LVD Timing Diagram Correction

SPI-3R3 Figure 44 & 45 correction

Proposed changes to the LVD ST Timing Diagrams
 -Figure 44

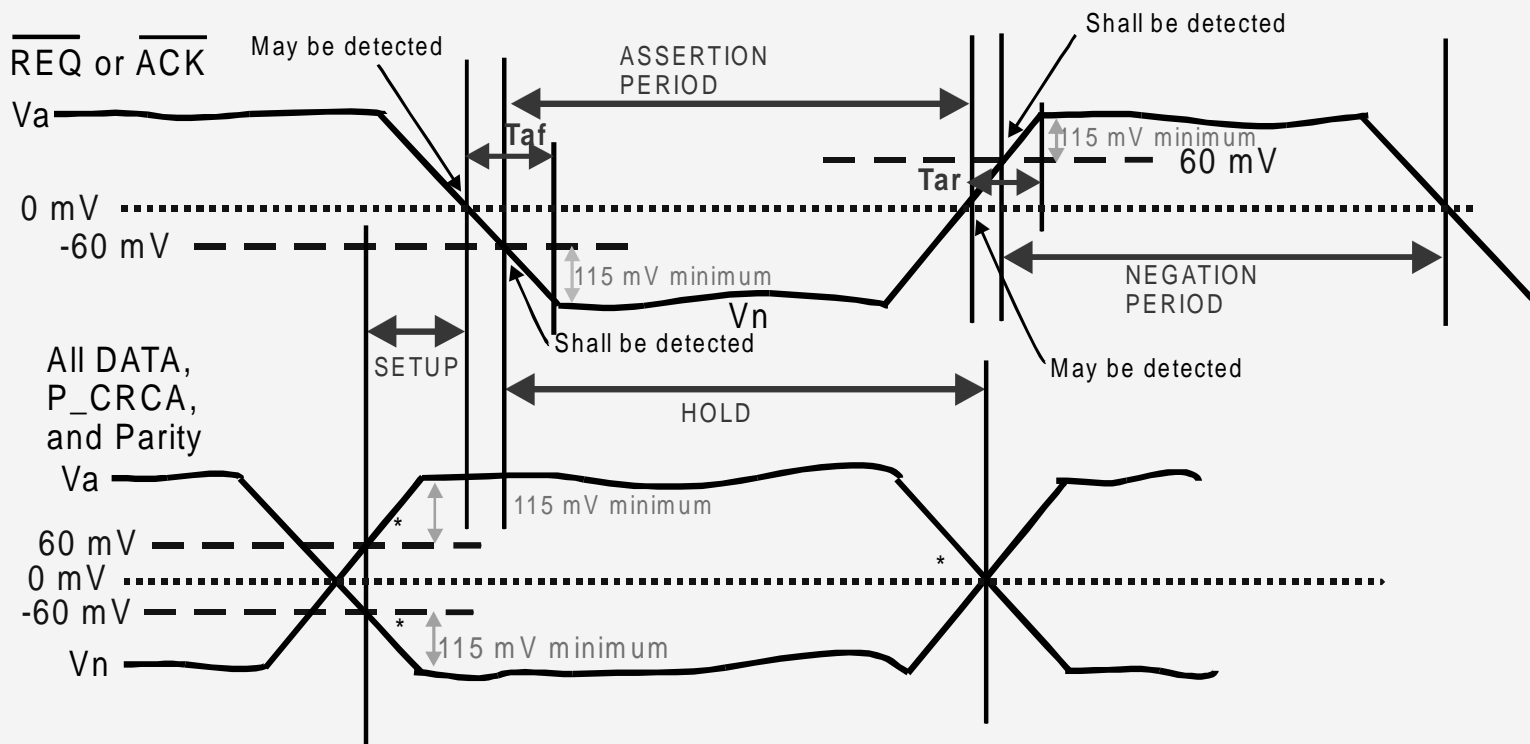
- The receivers require over drive to switch fast enough to not have skew problems.
- The receiver overdrive is not a function of the previous voltage, but a fixed 115 mV over the 60 mV AC threshold.
- AC measurement may switch is not 60 mV, it is 0 mV.
- No Receiver rise - fall time requirements specified

* Use the crossing that yields the shorter SETUP and HOLD Time
 V_a or V_n must over drive the 60 mV threshold by 115 mV at the leading edge of the transition.
 V_n = Negated Signal
 V_a = Asserted signal
 Differential voltage signals in all Cases
 T_{af} and T_{ar} must be less than 3 ns and receiver will only deliver one state change signal reversals may occur during the period.

Proposed changes to the LVD DT Timing Diagrams

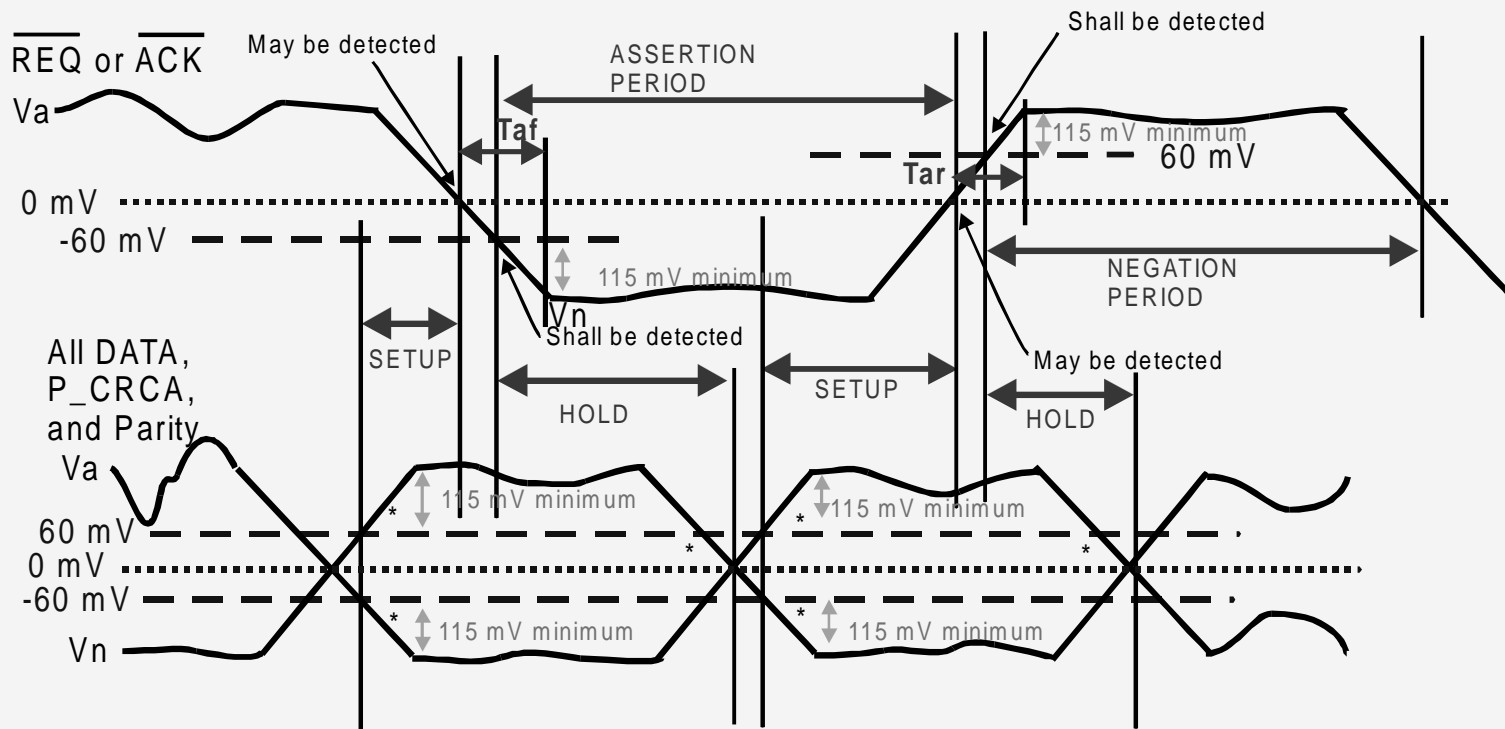
* Use the crossing that yields the shorter SETUP and HOLD Time
 V_a or V_n must over drive the 60 mV threshold by 115 mV at the leading edge of the transition.

V_n = Negated Signal

V_a = Asserted Signal

Differential voltage signals in all Cases

T_{af} and T_{ar} must be less than 3 ns and receiver will only deliver one state change signal reversals may occur during the period.
